Access Compliance Report

Public Rights-of-Way

(Curb Ramps)

Intersection ID: 44354	Main Street: LEGREE_LN	Cross Street: CHOATE_CR	Location:	N
ADA ID: 613C503868D2	Ramp Type: PerpDiag	Initial Pass/Fail: Fail	Overall Compliance: No	Severity Score: 21.25

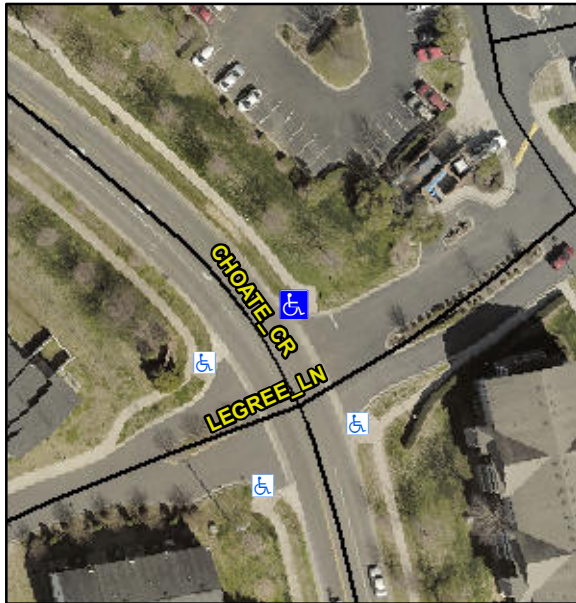
Not Found, R304.5.1, R304.5.3

Compliance	Description	Data	Compliance	Description	Data
N/A	Ramp Length (in)	98.0	Yes	Ramp Slope (%)	6.8
No	Ramp Width (in)	37.0	No	Ramp XSlope (%)	6.7
N/A	Flare Type LT	N/A	N/A	Flare Type RT	N/A
N/A	Flare Slope LT (%)	N/A	N/A	Flare Slope RT (%)	N/A
N/A	Flare Traversable LT?	N/A	N/A	Flare Traversable RT?	N/A
N/A	Landing Length (in)	N/A	N/A	DWS Provided?	N/A
N/A	Landing Width (in)	N/A	N/A	DWS Contrast?	N/A
N/A	Landing Slope (%)	N/A	N/A	DWS Length (in)	N/A
N/A	Landing X Slope (%)	N/A	N/A	DWS Full Width?	N/A
N/A	Landing Curb? (Y/N)	N/A	N/A	DWS Offset (in)	N/A
N/A	Shared Landing?	N/A			
N/A	Gutter Ponding?	N/A	N/A	Gutter Slope (%)	N/A
N/A	Gutter Lip Ht (in)	N/A	N/A	Gutter X Slope (%)	N/A
N/A	Painted X Walk1?	No	N/A	Painted X Walk2?	No
	X Walk 1 Direction	To SW		X Walk 2 Direction	To SE
N/A	X Walk 1 Width (in)	N/A	N/A	X Walk 2 Width (in)	N/A
	X Walk 1 Slope (%)	0.1		X Walk 2 Slope (%)	0.9
	X Walk 1 X Slope (%)	1.5		X Walk 2 X Slope (%)	7.5

Remove & Replace Curb Ramp With Two New Directional Ramps or Equivalent.
